# **PRODUCT TECHNICAL BULLETIN 36001**

## **MineCruiser Mk7 - Third Gear**

### **Declutch Pilot Valve**

Applicable Machines: MineCruiser Mk7s

**Figure 1: AR00199 / AR00067 item 22 declutch function (3<sup>rd</sup> gear only) Extract from MC49200 sheet 4 MineCruiser Mk6 & Mk7 registration drawing**

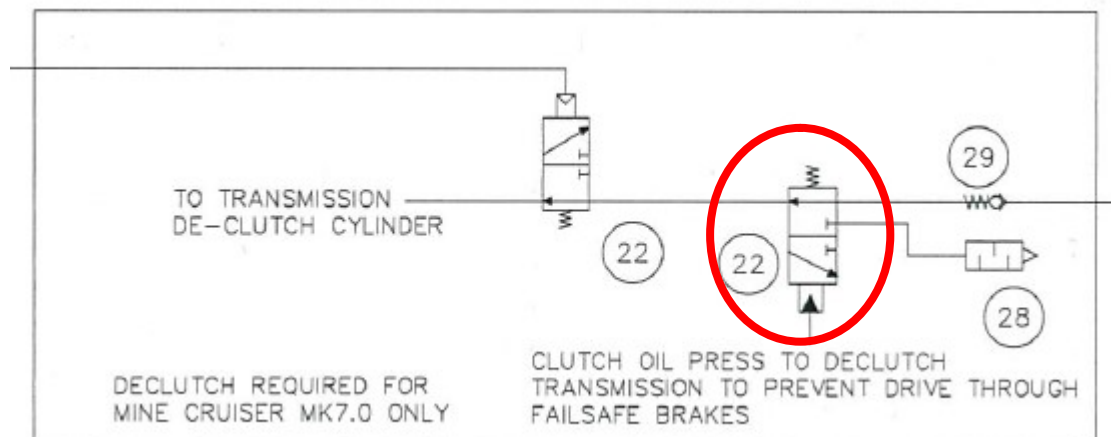
As the pilot pressure for this valve is taken from the transmission pressure, it is somewhat higher than the pneumatic system pressure. This has led to reports of the valves failing due to pilot pressures that exceed the valves specified operating parameters.

Due to these failures, an alternative valve has been reviewed and tested in the installation, replacing the existing AR00199 valve as identified in figure 1.

The alternate valve tested, 7-180405-711 performed the function successfully and is recommended as an alternate valve for this function.

This alternate valve does not impact the operation of the brake system in any other scenario and the failure modes and controls of this valve installation are the same as the original valve. The increased pressure and temperature rating make this valve more suited to the application in which it is used.

- At the next available service opportunity, replacement of the existing valve used in the 3<sup>rd</sup> gear declutch function AR00199 / AR0067 is recommended with the new valve 7-180405-711

- Maintenance and inspection of the valve are recommended at 1000hr intervals. The Valve should be inspected for leaking / contamination and the breather cleaned.

- The valve should be replaced at maximum of approximately 4000hrs of operation.
- This valve can be tested daily by attempting to drive thru the brakes with 3<sup>rd</sup> gear selected and the park brake applied. This test is specified as part of the In service braking test procedure for the MineCruiser in section 7.2 of document EB0022. As mentioned in the DFMEA, this is a crude park brake test only and is not a substitute for dynamic brake testing of the secondary/park brake.
